**Preliminary Comments on the
Proposed Revision of
NUREG-0654/FEMA-REP-1**

Edwin S. Lyman
Senior Scientist
Global Security Program
Union of Concerned Scientists
August 22, 2012

Dose rate in litate (19 miles NW)

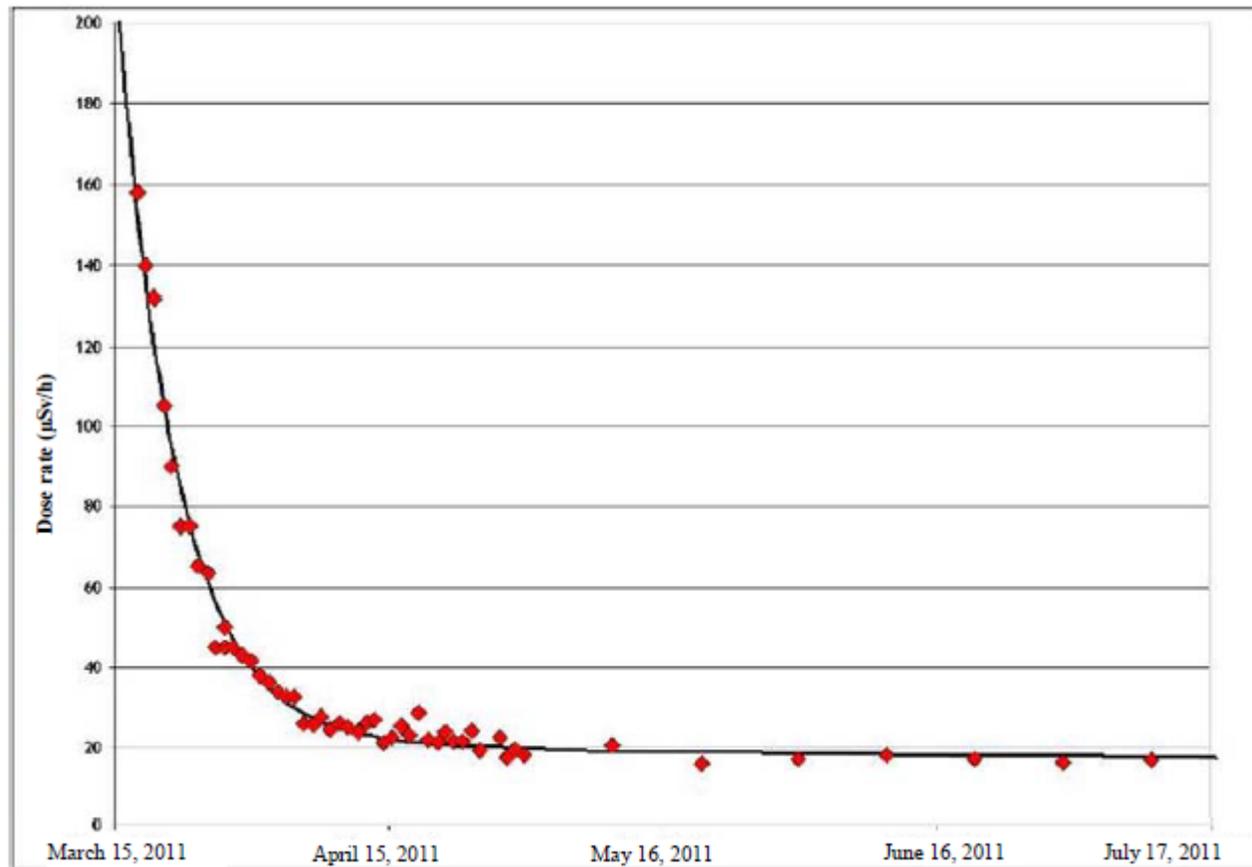
Fukushima ...

- Was not a “worst” core-melt sequence by any standard
 - Core melt did not begin for hours to days after initiation of accident
 - Large release did not occur until 24 hours after initiation of accident
 - Primary containment failure occurred late (if at all)
- Yet PAGs were likely exceeded well beyond 10 mile from the site
